Re: Adolfson & Peterson Site Plan Amendment Comment (01) Response Letter

Aurora Case No.: 1994-6017-05

ADOLFSON & PETERSON, INC. AURORA, COLORADO HEADQUARTERS FINAL DEVELOPMENT PLAN

APPROVED SITE PLAN IMPROVEMENTS VS PROPOSED IMPROVEMENTS (MINOR AMENDMENT SITE PLAN JUSTIFICATION DOCUMENT)

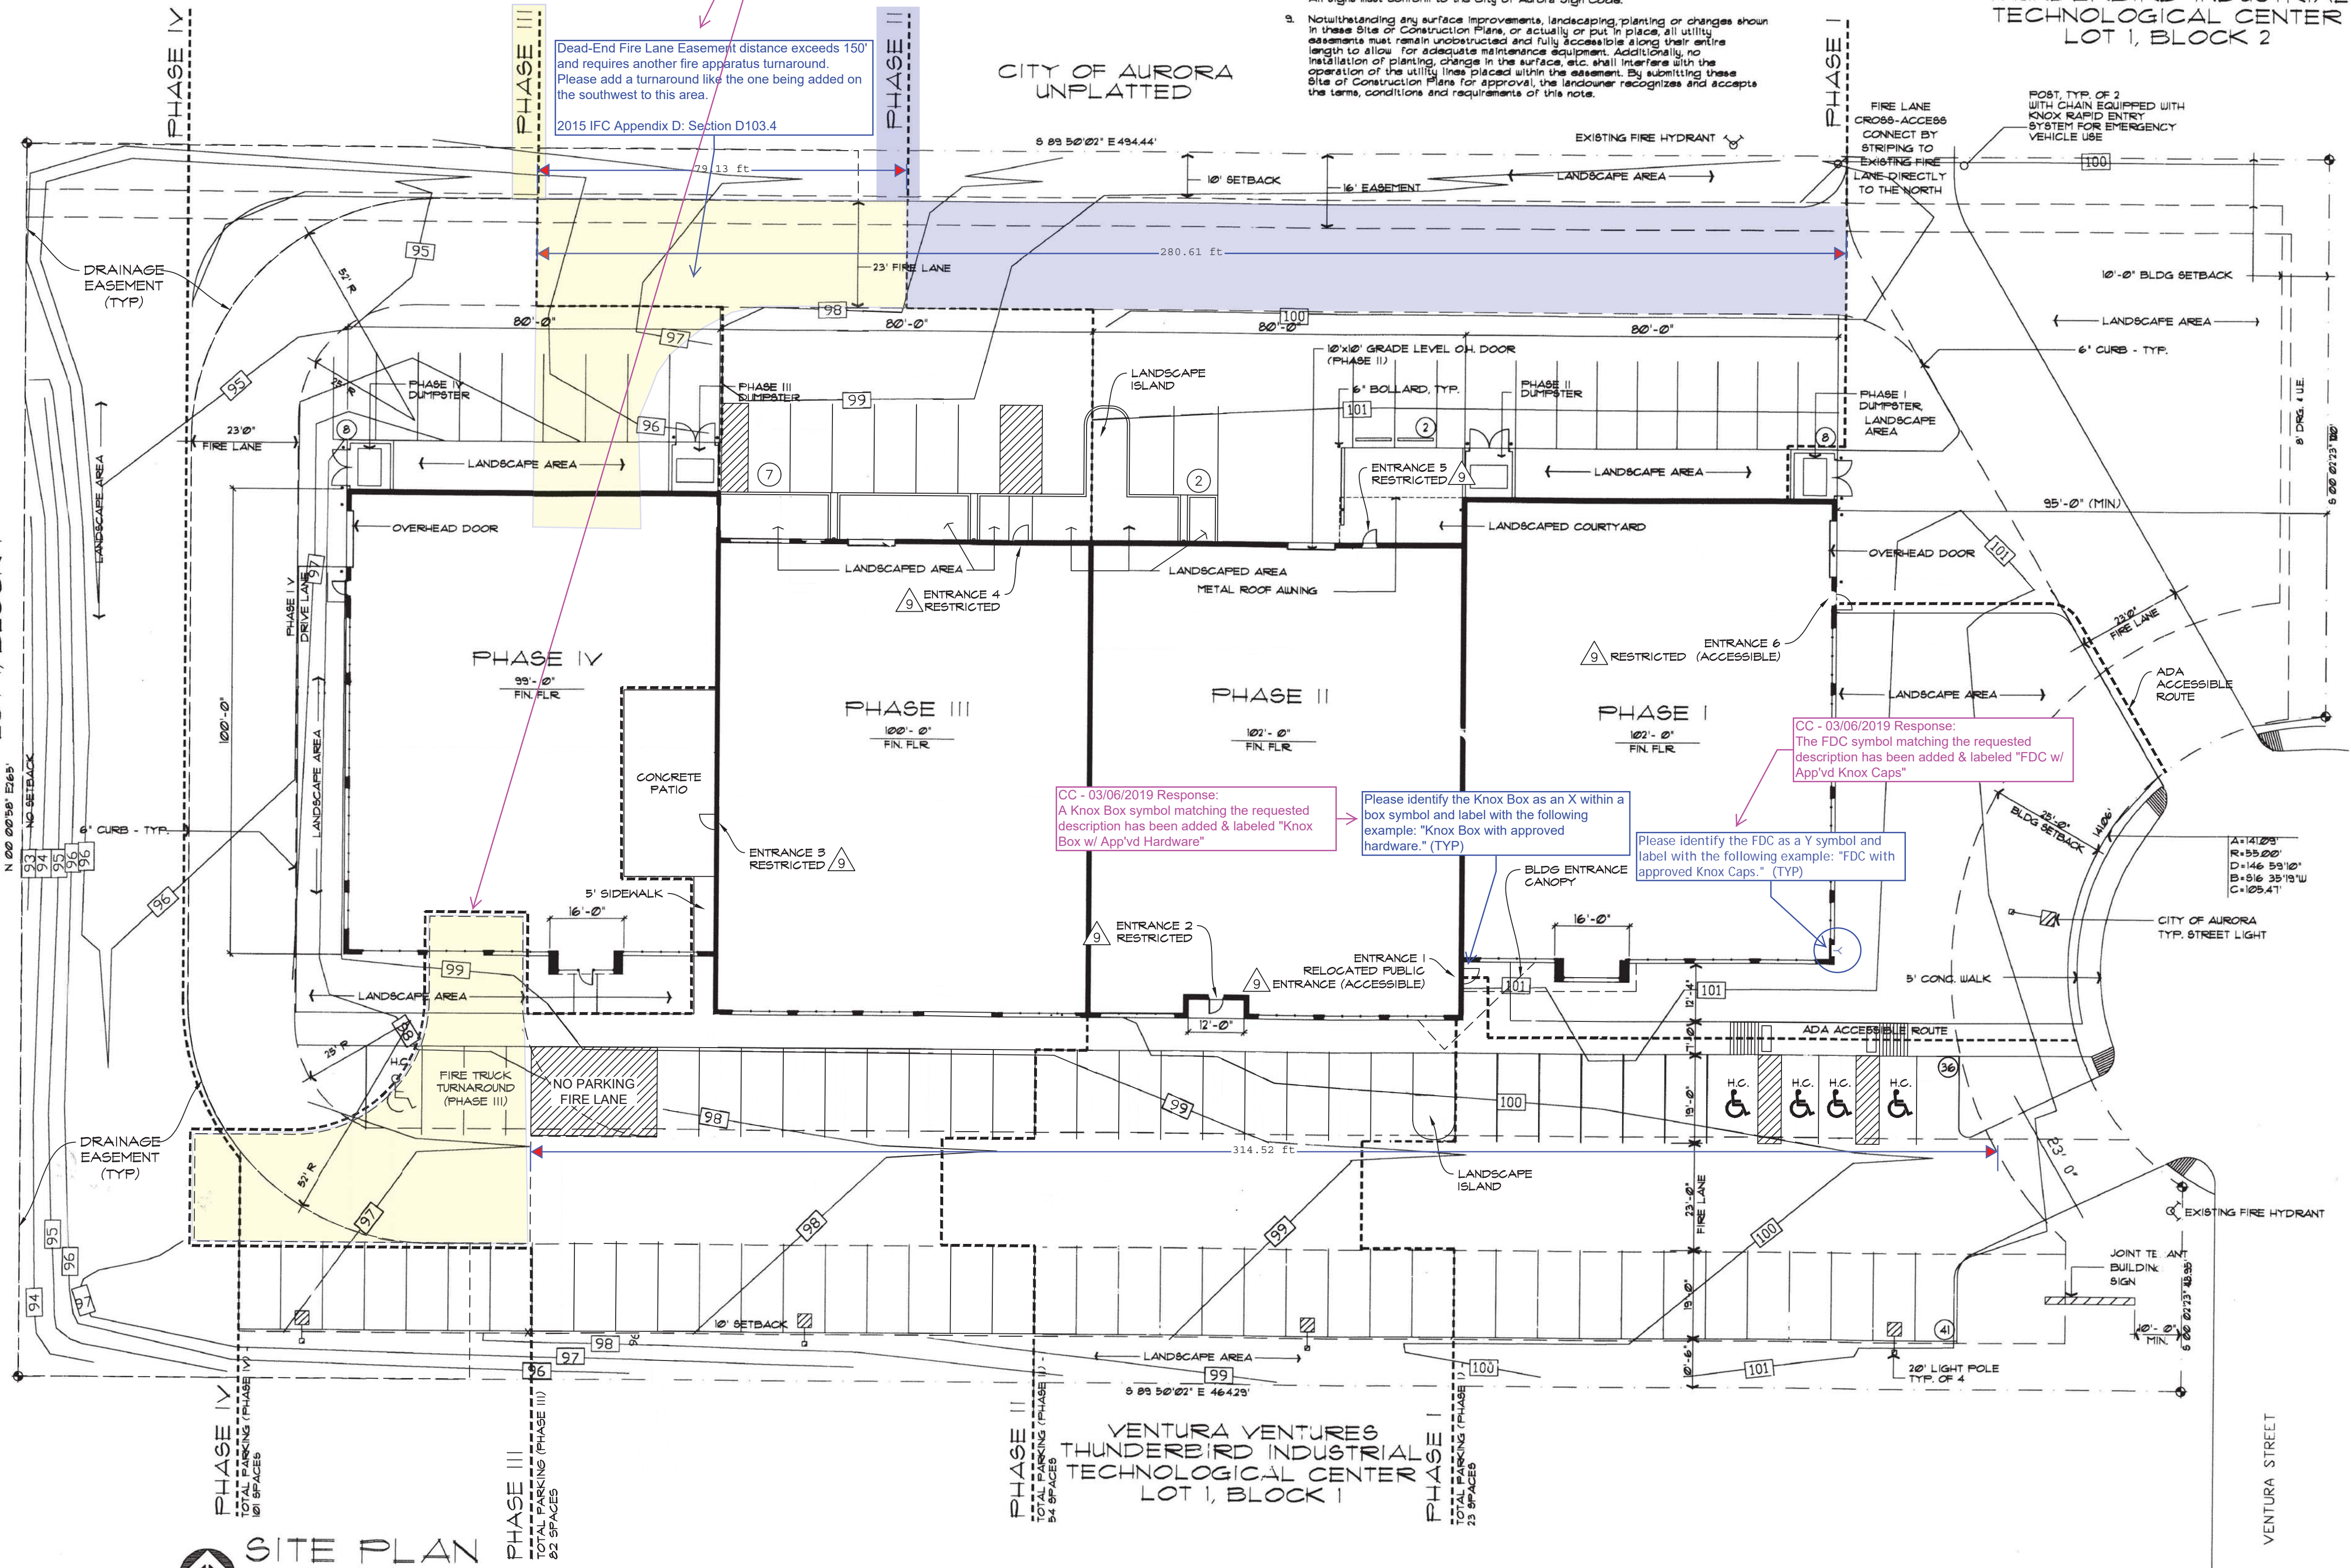
Page 3. Dead-End Fire Lane Easement distance exceeds 150' and requires another fire apparatus turnaround. Please add a turnaround like the one being added on the southwest to this area.

Page 3. Please identify the Knox Box as an X within a box symbol and label with the following example:

"Knox Box with approved hardware." (TYP).

Page 3. Please identify the FDC as a Y symbol and label with the following example: "FDC with approved Knox Caps." (TYP)

Dead-End Fire Lane Easement distance exceeds 150' and requires another fire apparatus turnaround. Please add a turnaround like the one being added on the southwest to this area.
2015 IFC Appendix D: Section D103.4

As coordinated with Greg Rogers on 03/05/2019, in lieu of providing two fire apparatus turnarounds, the Site Plan has been updated to indicate the fire lane as being extended to complete the fire lane loop around the Phase IV Building. Additionally, COA-Life Safety notes related to the fire lane (i.e. surfacing materials, load requirements, dimensions, etc.) have also been added to the Site Plan callout for the proposed fire lane loop completion.

A Knox Box, identified as an X within a box symbol has been added based on the location marked up on Page 3 with a label identifying "Knox Box w/ App'vd Hardware".

A FDC, identified with a "Y" symbol has been added based on the location marked up on Page 3 with a label identifying "FDC w/ App'vd Knox Caps".

CC - 03/06/2019 Response:
As coordinated with Greg Rogers (COA-Life Safety) on 03/05/2019, in lieu of providing 2 fire apparatus turnarounds, the Site Plan has been revised to indicate that the fire lane loop will be completed around the west side of the Phase IV Building & COA Life Safety notes related to fire lane requirements (surfacing, dimensions, etc.) have also been added to the Site Plan
